**Council Meeting
Under Separate Cover**

Macedon Ranges Planning Scheme Amendment C153macr
Permit Application PLN/2022/359
Willowbank Road Local Activity Centre

Panel Report

8 December 2023

Figure 4 Walkable catchments of the proposed local activity centre and the Gisborne Town Centre

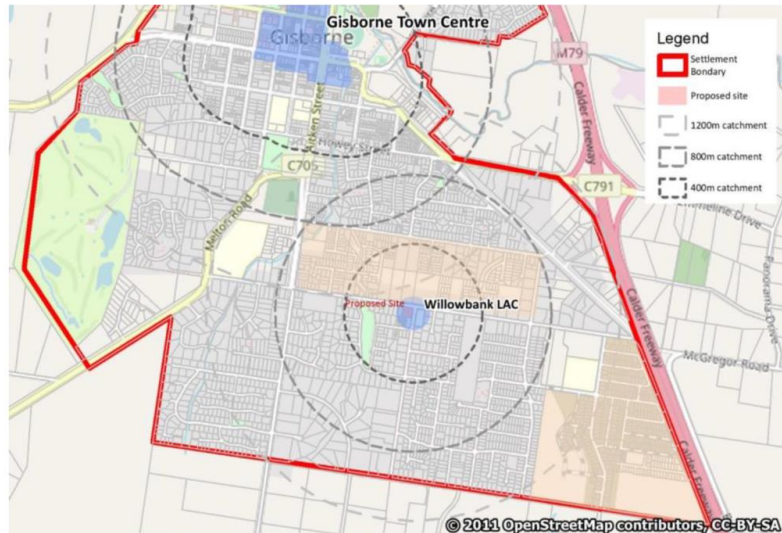
Mr Szafraniec analysed the walkable catchments of the proposed centre and the main town centre (see Figure 4). He noted:

Mr Szafraniec noted there are no medical centres or hospitals within the local walkable catchment. The proposed development would provide walkable access to a medical centre for surrounding residents, addressing a current gap. He considered the medical centre would be supported by the existing physiotherapy and osteopathy clinics which "*could enable more a more unified and holistic local health care offer*", particularly beneficial for residents of the two future aged care facilities.

Figure 5 Draft Gisborne Framework Plan August 2023

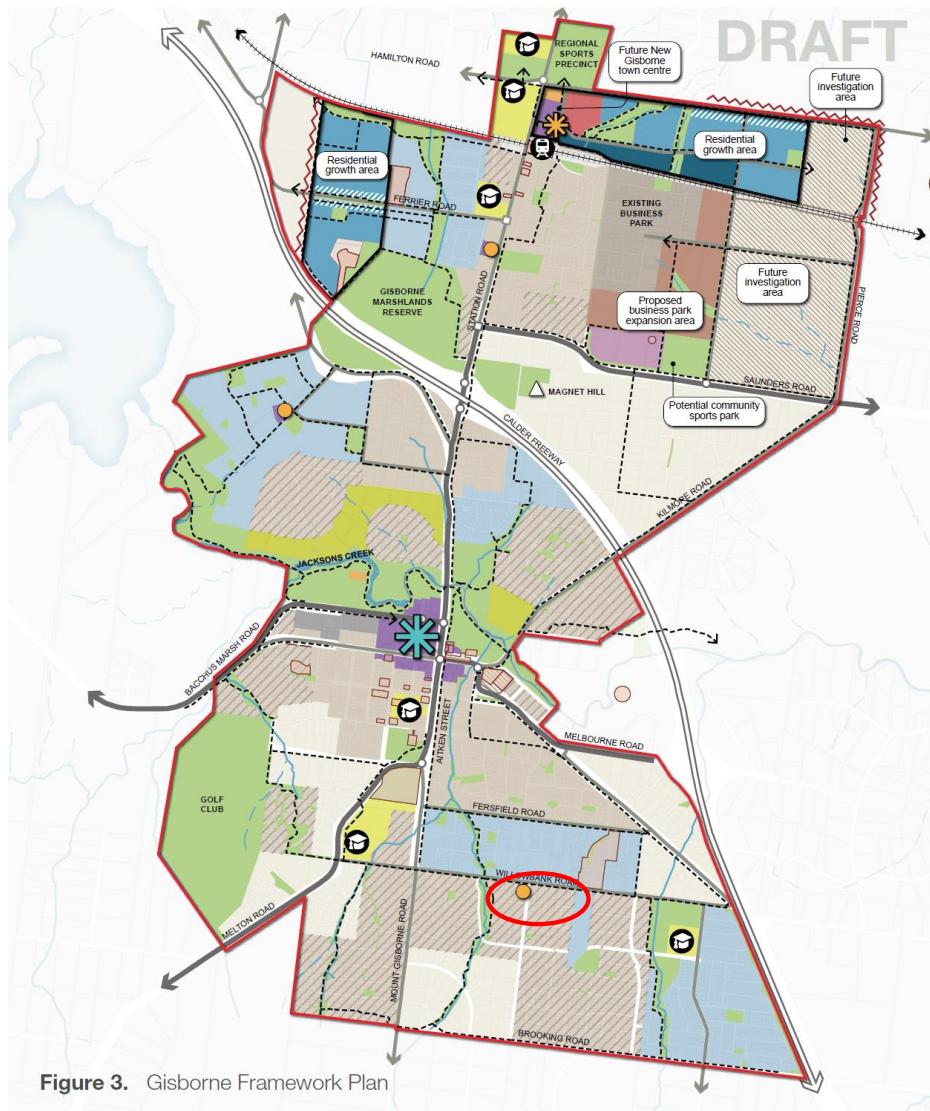
The August 2023 draft includes a Framework Plan for Gisborne, which shows a local activity centre on the corner of Willowbank and Brady Roads (see Figure 5 below). It notes the current proposal for the development of the site, and Section 4.3 – Local activity centres, includes:

The Structure Plan will eventually replace the Gisborne ODP, but is not yet part of the Planning Scheme. Accordingly, the Panel has afforded more weight to the ODP than the Structure Plan, although it notes they are consistent in terms of identifying the site as a location for a future local activity centre offering the types of services that are included in the proposal.
